Type Coffee Vending Machine	Model 9100	N° T.I. 02 - 2021					
Serial Number See Below	Subject LEAD FREE INTRODUCTION	ISSUED FOR (X)	<table border="1"> <tr> <td>Action</td> <td></td> </tr> <tr> <td>Information</td> <td>X</td> </tr> </table>	Action		Information	X
Action							
Information	X

Be informed that with the aim to improve our equipment, the Lead Free components has been introduced for the 9100 machines.

EVS GROUP and ATTACK

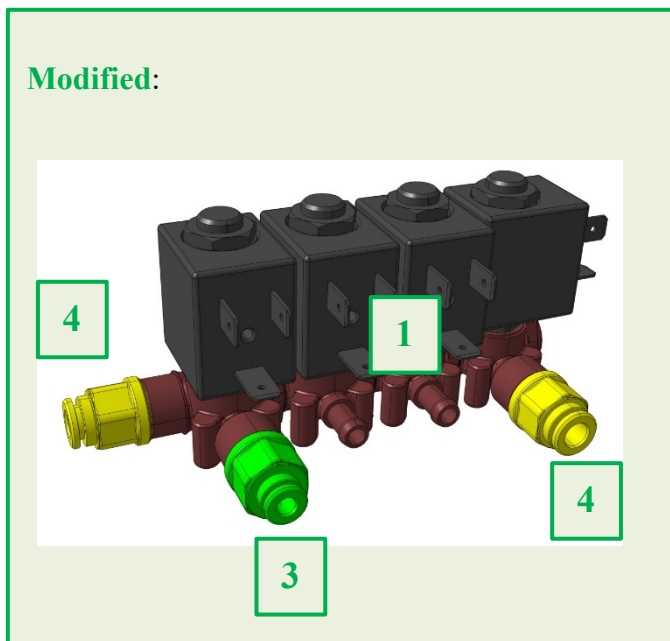
Modified:

Pre-modification:

Description	Spare Code
1	Evs Group plastic	264389
3	Straight fitting for teflon-4 (coffee)	264387
4	Straight fitting for teflon-6 (hot water)	263425

Description	Spare Code
1	Evs group brass	259931
2	Rubber holder	099012
3	L-swivel for teflon-4 (coffee)	256273
4	Straight fitting for teflon-6 (hot water)	257047

EVS ON BOILER

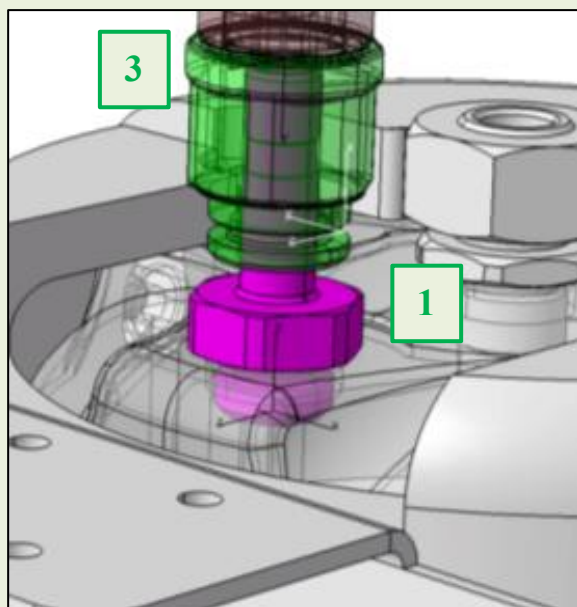
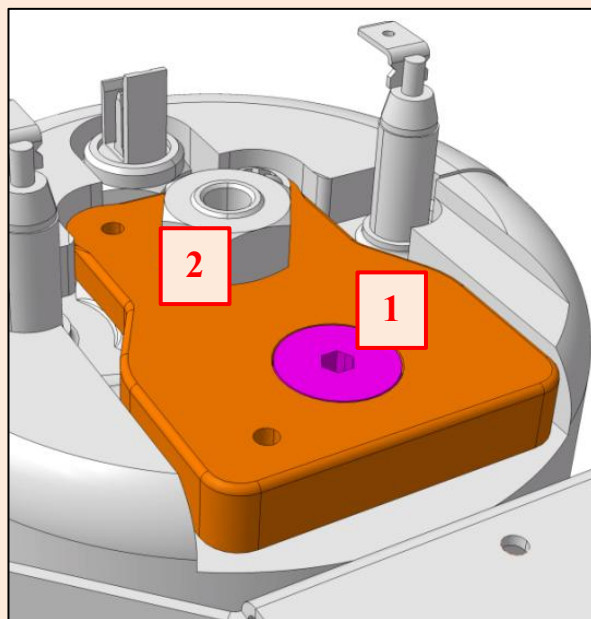
Modified:

Pre-modification:

Description	Spare Code
1 Boiler outlet fitting	264384
3 Straight fitting for teflon-6	263425

Description	Spare Code
1 Boiler outlet fitting	261358
2 Inductive plate	257343

IN / OUT BOILER

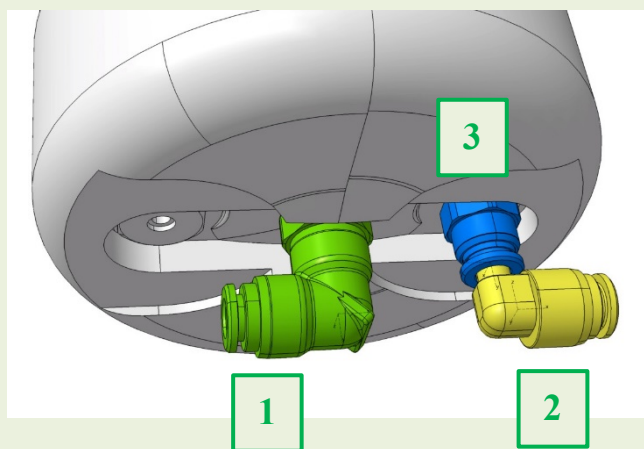
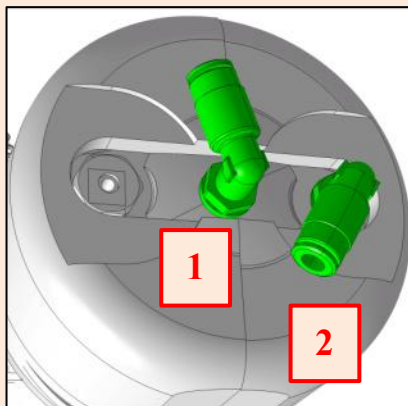
Modified:

Pre-modification:

Description	Spare Code
1	Tube swivel fitting for teflon-6 (boiler inlet)	264385
2	Swivel fitting for teflon-6 (boiler drain)	263427
3	Straight fitting d.6 inox	264386

Description	Spare Code
1	Tube swivel fitting for teflon-6 (boiler inlet)	258904
2	Swivel fitting for teflon-6 (boiler drain)	256280

EV Z4000 -ES/FB

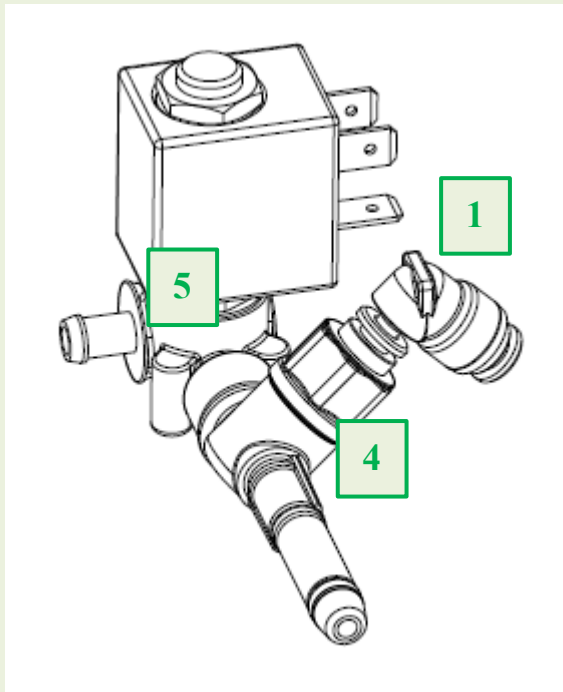
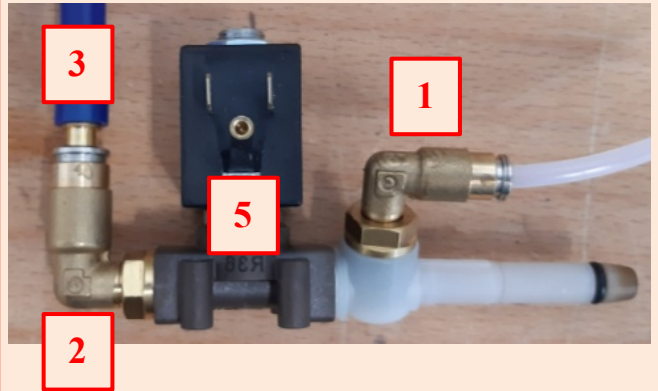
Modified:

Pre-modification:

Description	Spare Code
1	L-swivel for teflon-4	264388
4	Straight fitting for teflon-4	264387
5	EV	264390

Description	Spare Code
1	L-swivel for teflon-4	256273
2	Swivel fitting for teflon-6	256280
3	Teflon / silicone adapter	258914
5	EV	258764
